PD Modification Application: PRS 25-0759**Zoning Hearing Master Date:** N/A**BOCC Land Use Meeting Date:** July 22, 2025**Hillsborough
County Florida****Development Services Department****1.0 APPLICATION SUMMARY****Applicant:** Eisenhower Property Group, LLC**FLU Category:** Suburban Mixed Use-6 (SMU-6)**Service Area:** Urban**Site Acreage:** 121.7 MOL**Community Plan Area:** Riverview & South Shore Areawide Systems**Overlay:** None**Introduction Summary:**

The applicant is requesting a minor modification to PD 24-0697 to remove Conditions 8.4 and 23, eliminating a required pedestrian/bicycle connection and trail. The PD consists of four development pockets. Due to environmental features, Pockets 1, 2 and 4 are not interconnected with Pocket 3. Existing conditions were approved to provide connection to Pocket 3 from other areas of the PD.

2.3 Approved Site Plan (partial provided below for size and orientation purposes. See Section 7.1 for full site plan)

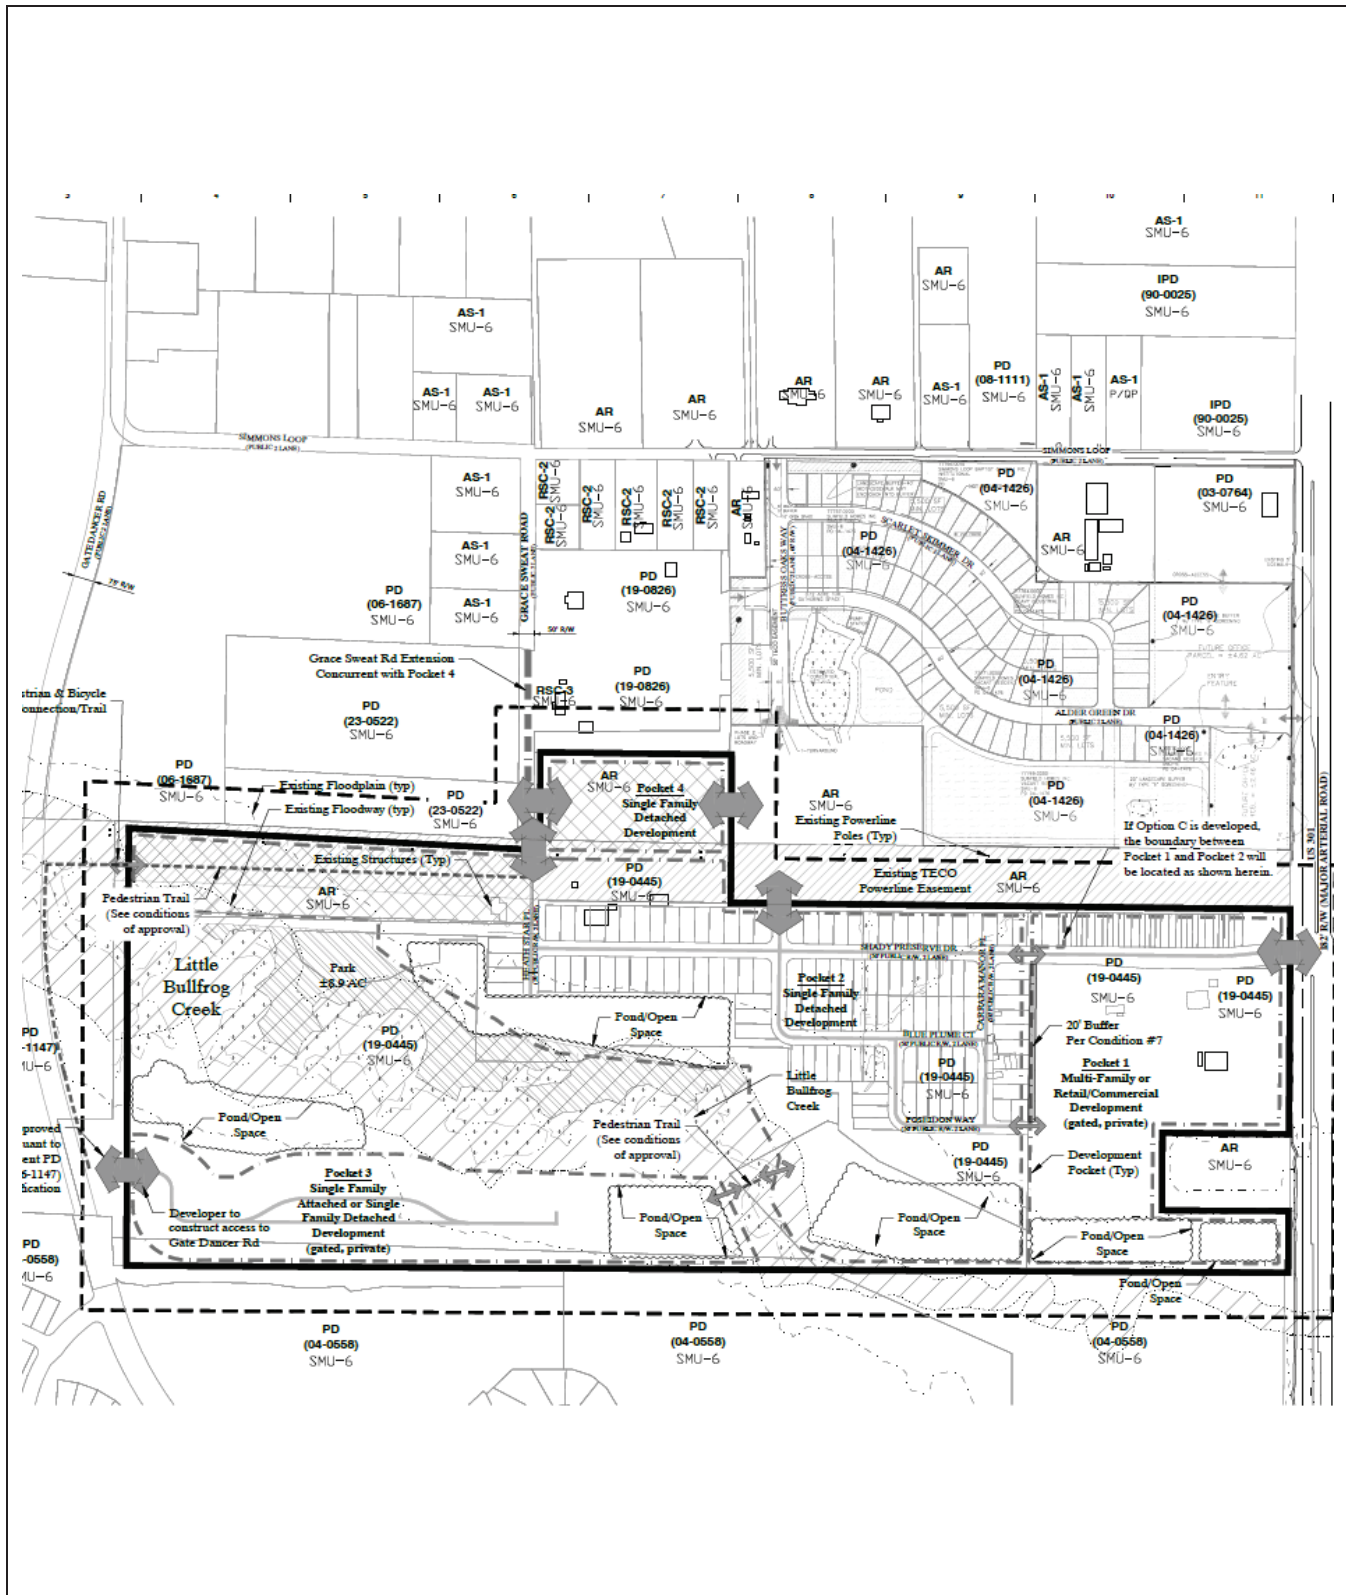
Existing Approval(s):	Proposed Modification(s):
A pedestrian connection between Pocket 2 and 3 shall be provided. Alternatively, a pedestrian connection between Pocket 4 and 3 via Gate Dancer Road shall be provided.	Pedestrian connection requirement removed.
A pedestrian and bicycle trail connection between Grace Sweat Rd. and Pocket 4 via Gate Dancer Rd. shall be constructed by the developer.	Pedestrian and bicycle trail connection requirement removed.

2.4 Proposed Site Plan (partial provided below for size and orientation purposes. See Section 7.2 for full site plan)

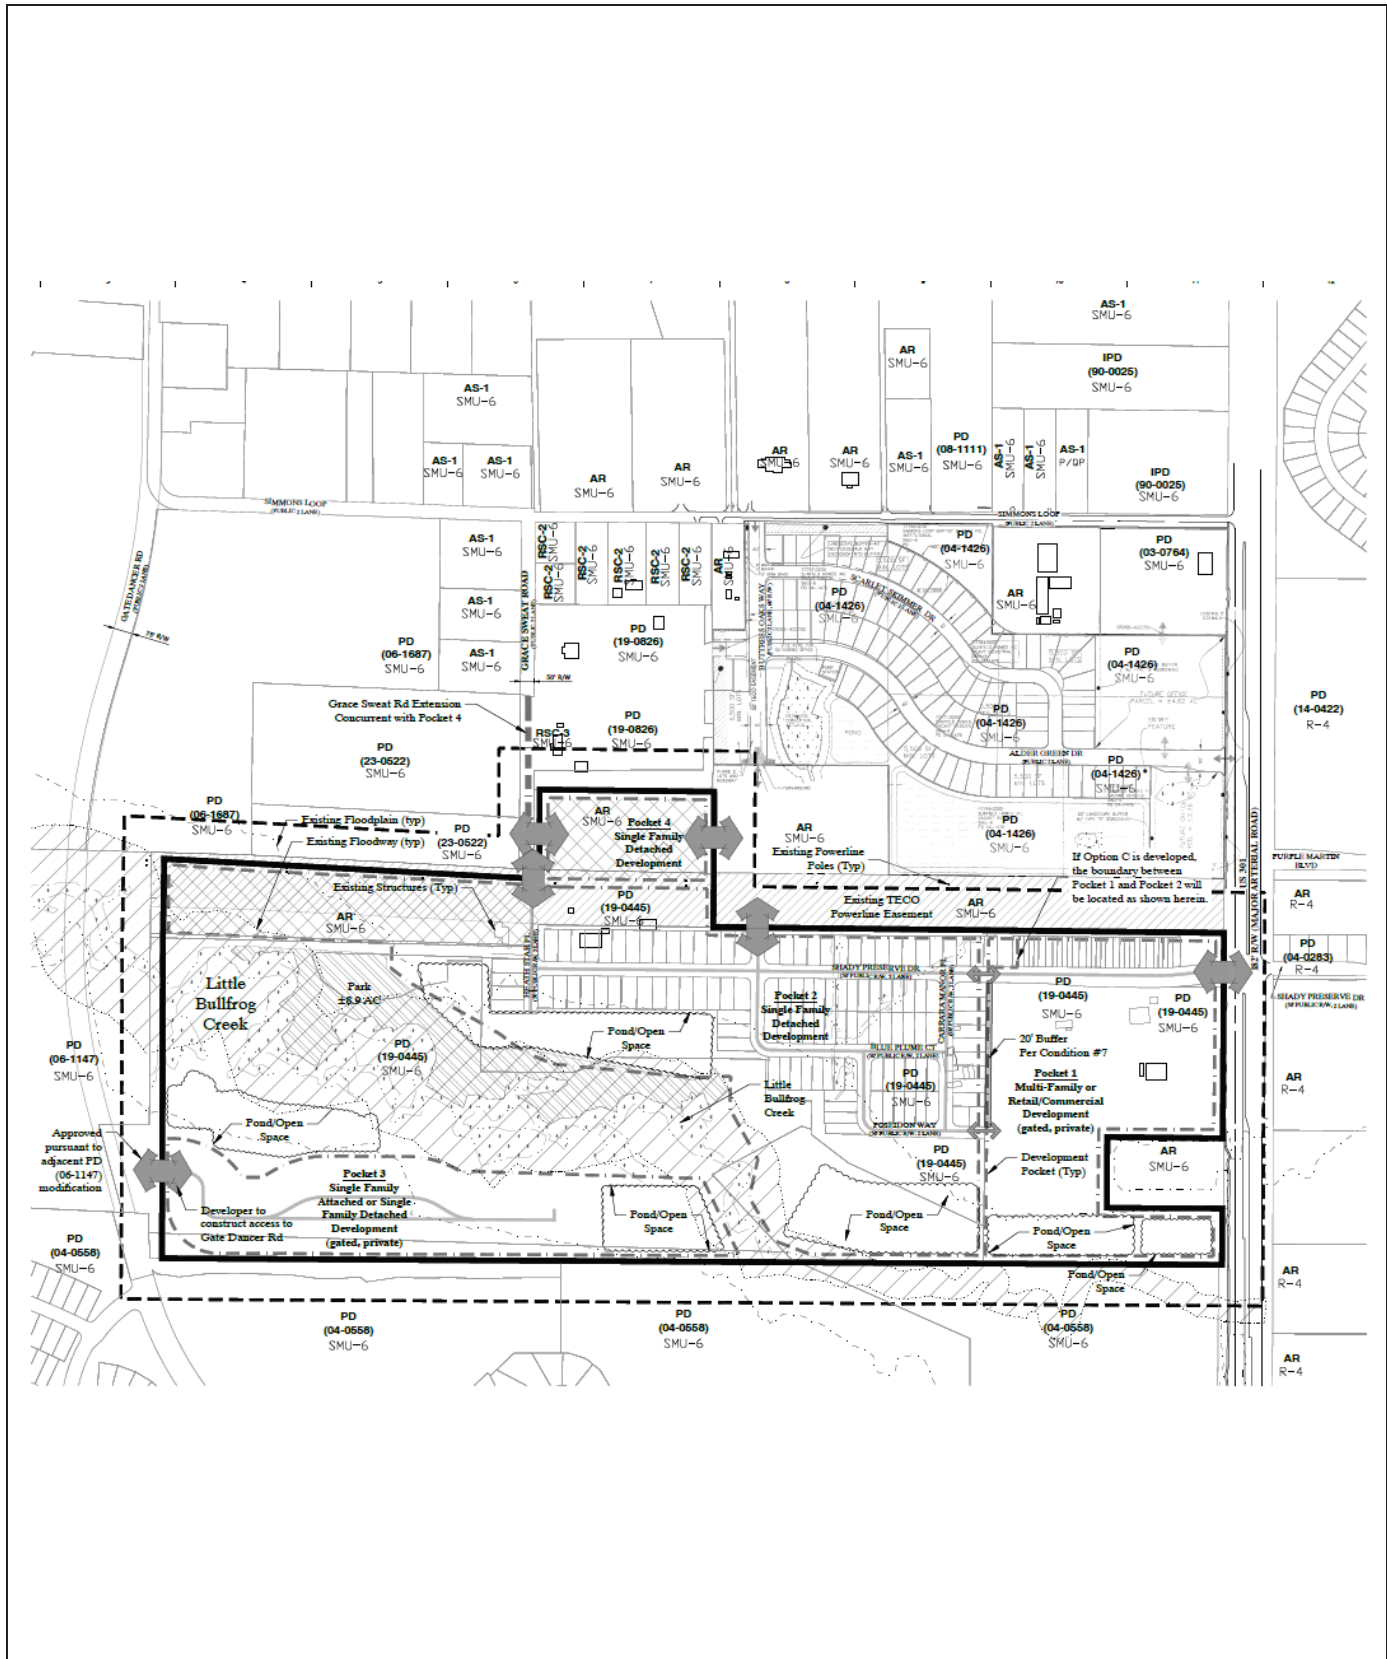
Notes: The removal of the pedestrian connection between Pockets 2 and 3 eliminates access to Gate Dancer Rd. for Pockets 1,2, and 4.

7.2.1 Proposed Site Plan (Full)

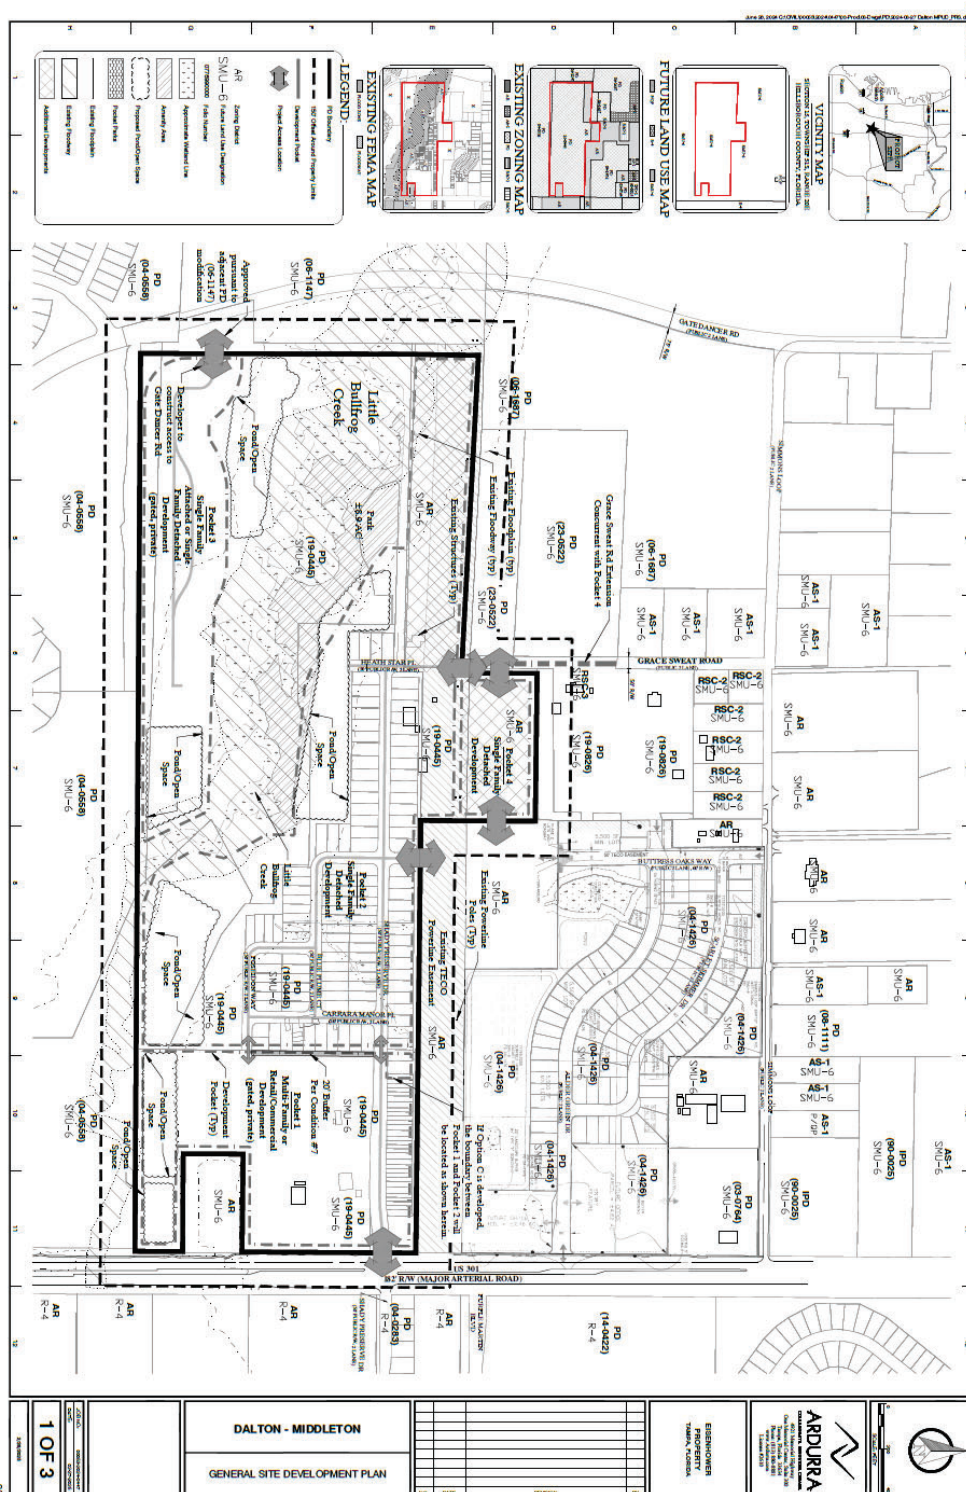
- 8.4 ~~As depicted on the general site plan, a pedestrian connection between Pocket 2 and 3 shall be provided. Installation of the pedestrian connection shall be done at the site development of Pocket 2 or 3, whichever occurs last. Alternatively, as depicted on the general site plan, a pedestrian connection between Pocket 4 and 3 via Gate Dancer Road shall be provided. Compliance with this requirement shall be done at the site development of Pocket 3 or 4, whichever occurs last.~~

- 22.3 With the initial plan submittal for development of Pocket 4, the County will contact FDOT to make them aware of the development.
- ~~23. As depicted on the PD site plan, a pedestrian and bicycle trail connection between Grace Sweat Rd. and Pocket 4 via Gate Dancer Rd. shall be constructed by the developer. The trail shall be a minimum 10-foot wide Americans with Disabilities Act (ADA) compliant surface except where there is a separate bike lane located along the route, a 5-foot wide sidewalk will suffice. In the event that it is determined that the trail is not required to be ADA compliant, it shall be constructed with a durable and dustless surface.~~
